1964 Corvette: Service Bulletin: Neutral Safety Switch Malfunction

Model and Year: 1964 Corvettes with Powerglide Transmissions

Bulletin No: DR #658

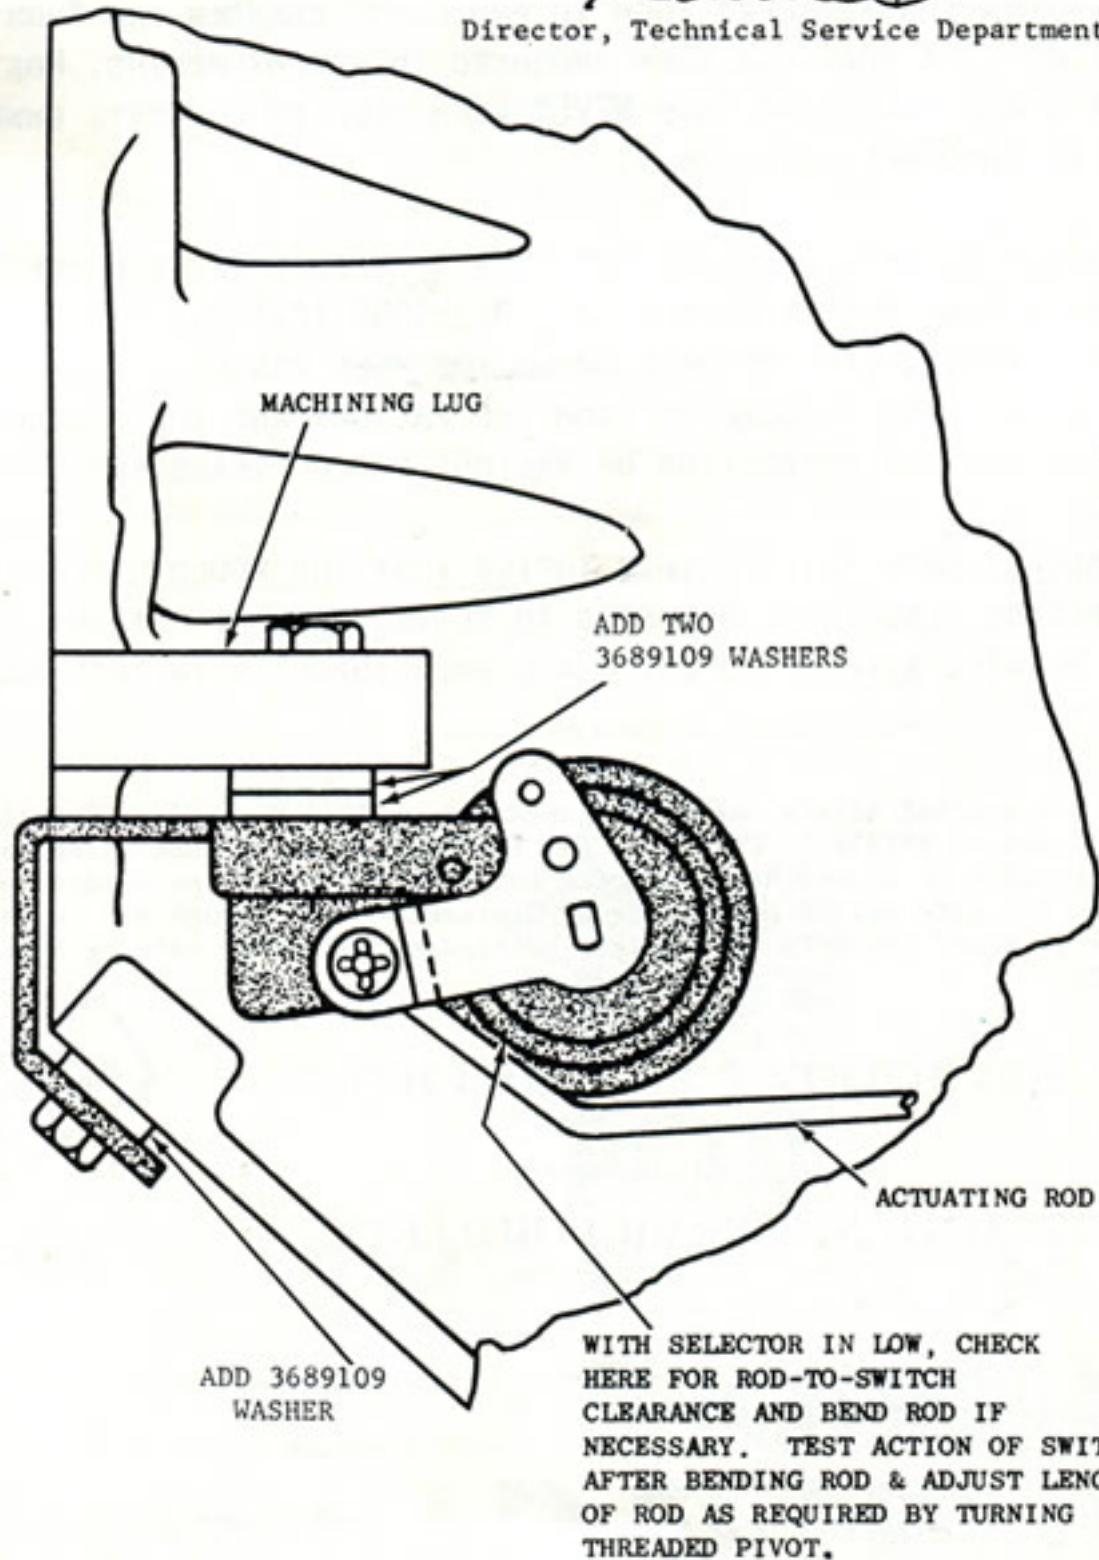
Interference between the neutral safety switch and the underbody may exist on some early production Corvette Models with Powerglide transmissions.

This could result in the engine being started while the transmission selector is in a drive position. In addition, the added load imposed on the shift linkage by the misalignment causes a reduction or loss of detent feel when the transmission is shifted manually. The transmission might then be accidentally operated between ranges and internal damage could result.

Correction of switch malfunction may be made by shimming the switch assembly downward as shown in the attached sketch. Note that operating clearance must exist between the switch body and the switch actuating rod after the shimming operation is completed.
